SCS ENGINEERS

May 17, 2000
File No. 09195029.35

Subject: Response to Request for Additional Information
Southeast County Landfill Capacity Expansion - Section 1
Pending Permit No.: 35435-004-SC

| DRAWING TITLE | VICINITY AND LAND USE MAP SECTION 1 |

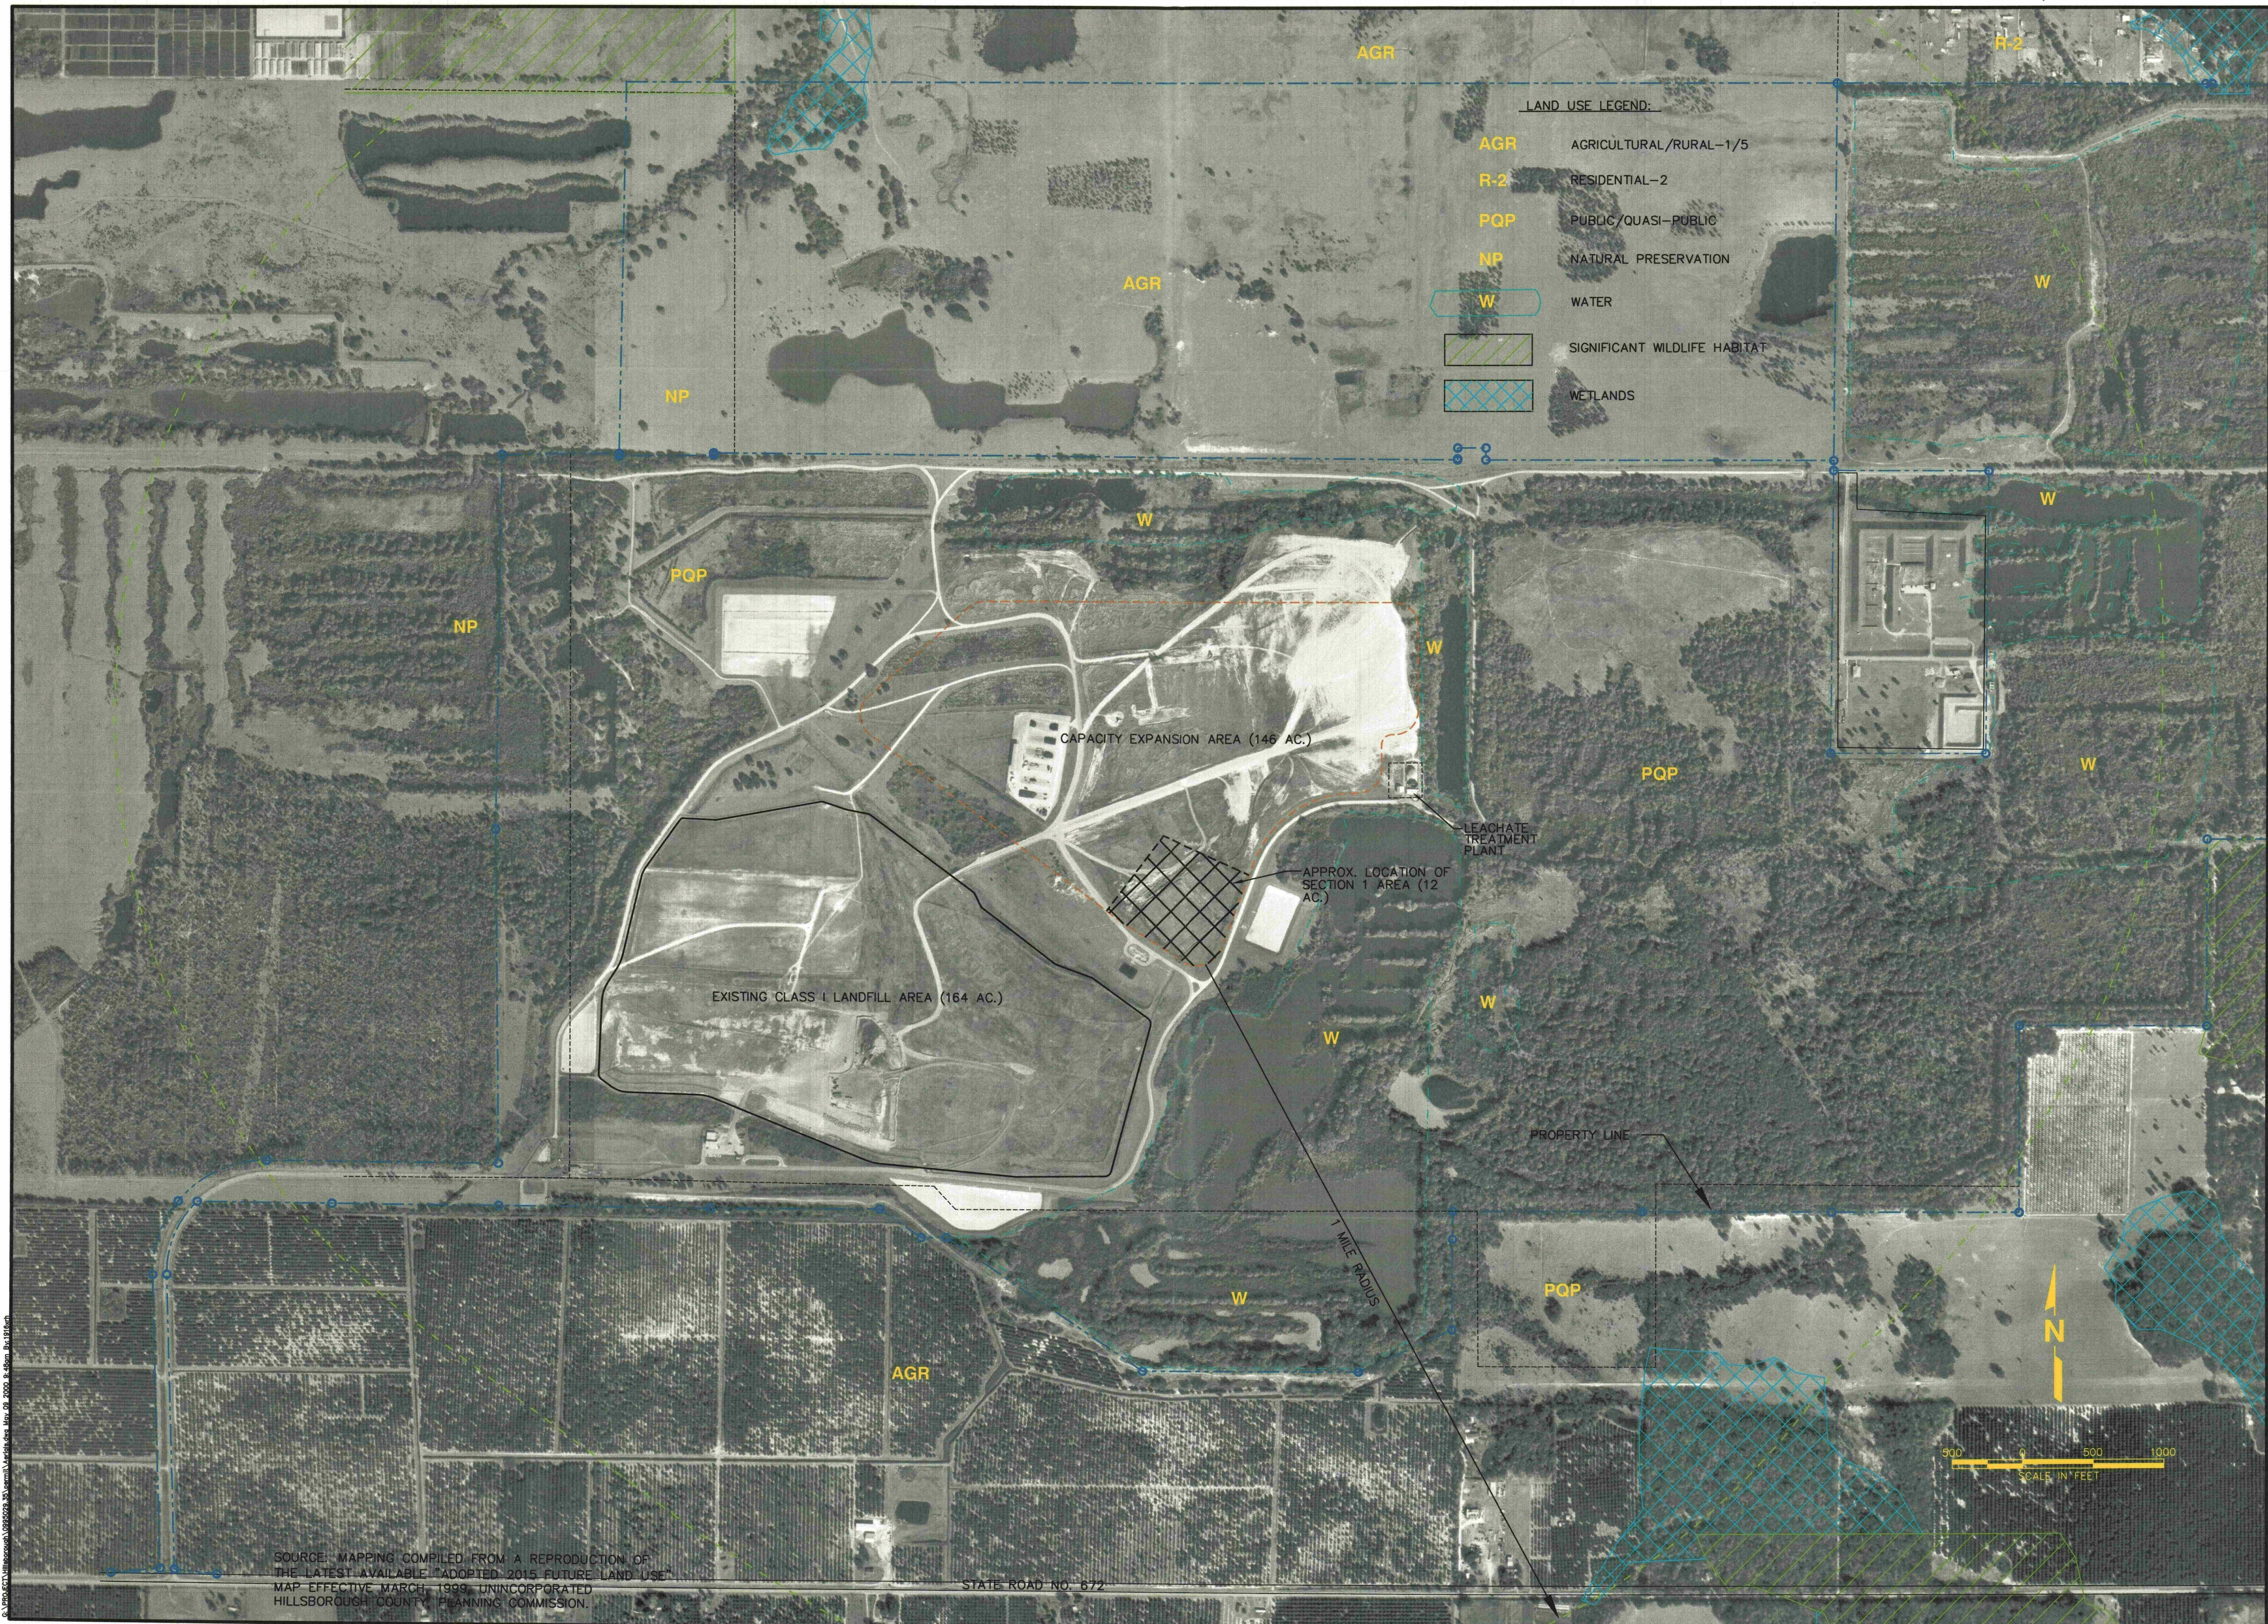
FDEP Statement 4 - 62-701.330(4)(a). Full-size aerial photograph with topographic information showing all required information.

Response: Attachment 2 presents a full-size aerial photograph with land use, water bodies, and roads within a one-mile radius of the site. In addition, Attachment 2 contains the topography adjacent to the site as depicted on the most recent USGS map.

Sump Volume Storage

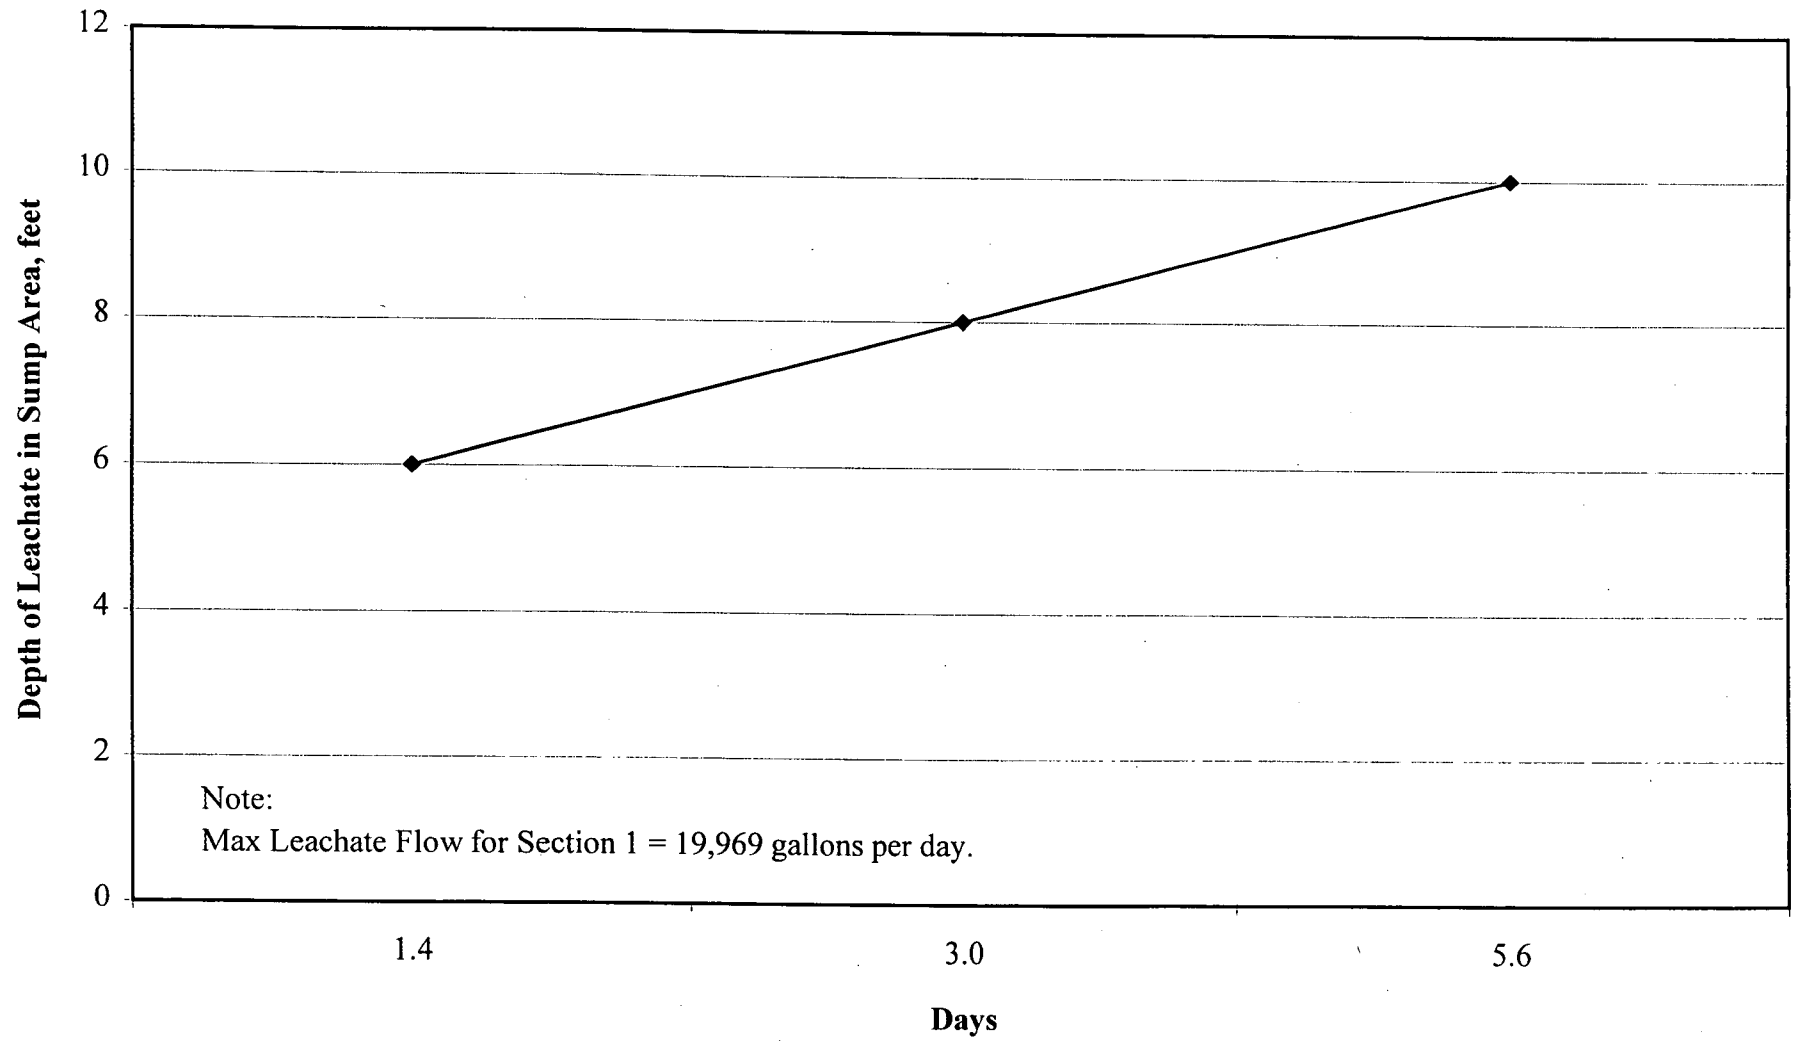
FDEP Statement 7 - 62-701.400(3)(a). Calculations for the proposed disposal area sump to demonstrate that adequate capacity will be available to prevent overtopping containment berms in event of pump failure.

Response: Calculations demonstrating that the sump has adequate capacity in the event of a pump failure are presented in Attachment 6.

Figure 1. Post-Development Drainage Basins.

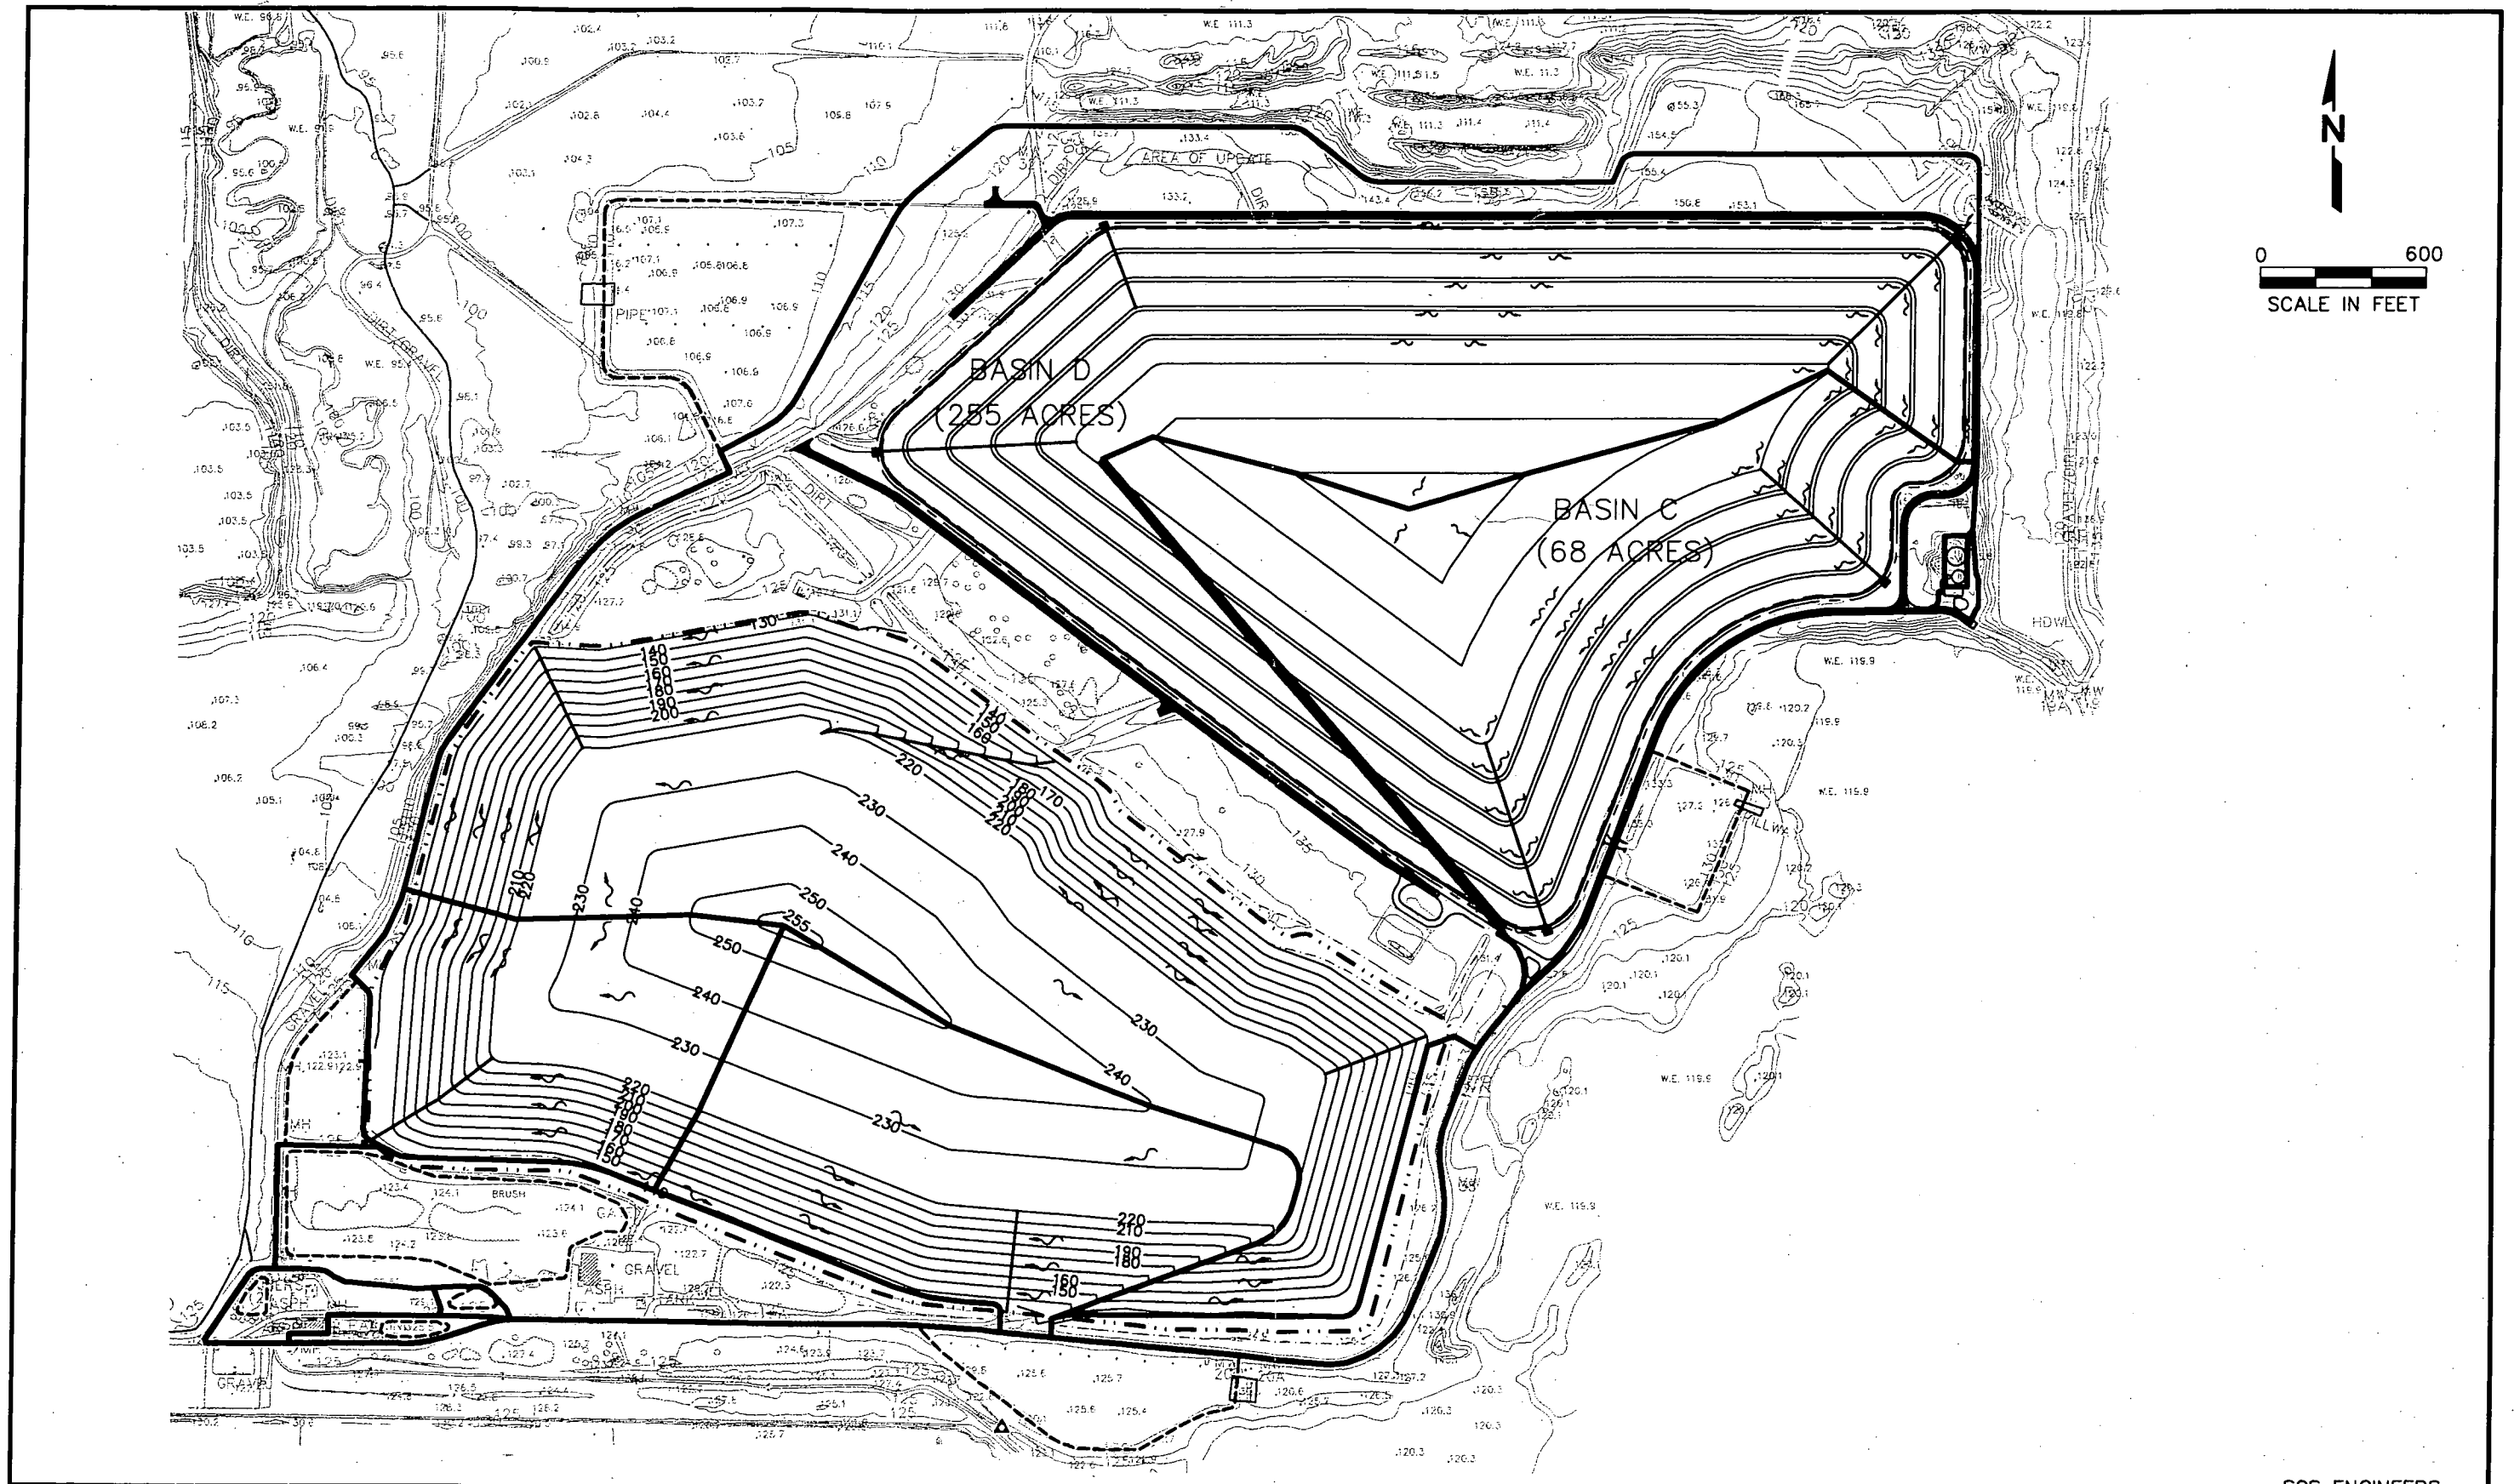
1. Clarify drainage divides: Attachment 10 presents a revised post-development drainage map.
2. Clarify pond construction activities: Ponds C and D will not be modified during the construction of Section 1. However, prior to the construction of Section 8, the perimeter berm for Pond C will be raised in places to establish a common elevation of 132 NGVD. Since the time the banks for Pond C were constructed, settlement and erosion have caused minor saddles or low points near the top of the berms. For Pond C, the sheet titled "Pond C (proposed)" can be removed. For Pond D, the sheet titled "Pond D (existing)" can be removed, and the sheet titled "Basin D" had a typographical error for the area associated with elevation 116. The correct area for elevation 116 is 675,819 square feet, not 975,819 square feet. This revision does not impact the routing calculation, because the peak elevation in the pond only reached 109.59.

REVISED PLOT

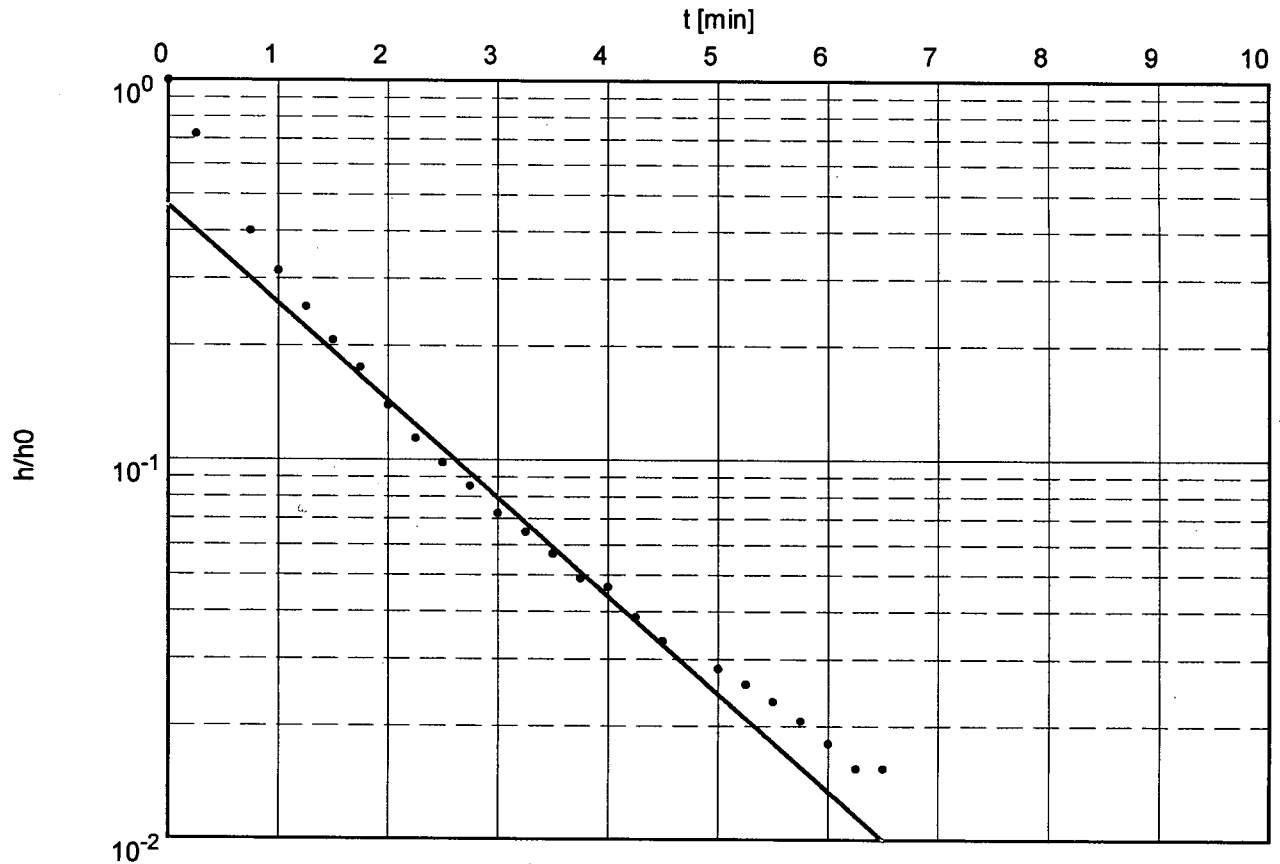
b. The raw data for water level and drawdown measurements that were recorded during the slug test, and of the values for residual head (H/H_0) were compared with the graphical presentation of each of the slug tests. The plots of residual head vs. time for five of the six slug tests were unclear. Please review the plots for P-1D (time scale is inconsistent), and P-2S/P-2D/P-4S/P-4D (calculated residual head values do not match the individual data points), and revise as necessary.

Response: The revised plot for P-1D is presented in Attachment 13. The y-axes in the computer program is comprised of the residual head divided by the original head value. The residual head value is not plotted directly. The plots are correct when dividing the residual head by the original head.
